Report: TAB REPORT
Function: Test, Adjust, & Balance
Date: 10/06/2023

09-04-23 PENN STATION - BELLEVUE, NE

Table Of Contents

GRD
09/11/2023

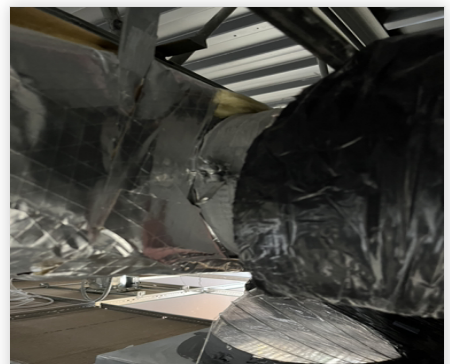
Issue Name : DIFFUSER 2-9 plastered shut
Description : Damper on diffuser 2-9 on the GRD is plastered shut and is allowing no airflow through. The damper needs to be free to be locked down at the proper airflow.
Created By : National TAB **Assigned To :** National TAB - Jacob Davidson
Status : Open
Priority : **Asset Tag :**
Originated Date : 09/11/2023 - Jacob Davidson - National TAB

EF3(1)
09/12/2023

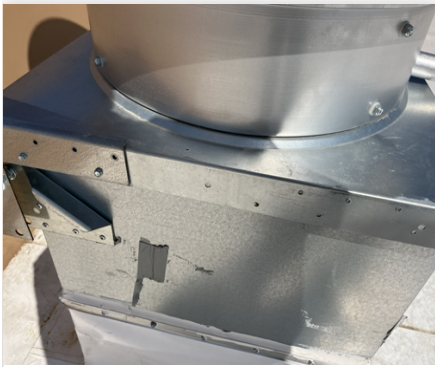
Issue Name : EF1 and EF3 air leakage
Description : On the sides of EF1 and EF3 there is air leakage which will have grease escape onto the roof. Recommend sealing off the sides of these fans.
Created By : National TAB **Assigned To :** National TAB - Jacob Davidson
Status : Open
Priority : **Asset Tag :**
Originated Date : 09/12/2023 - Jacob Davidson - National TAB
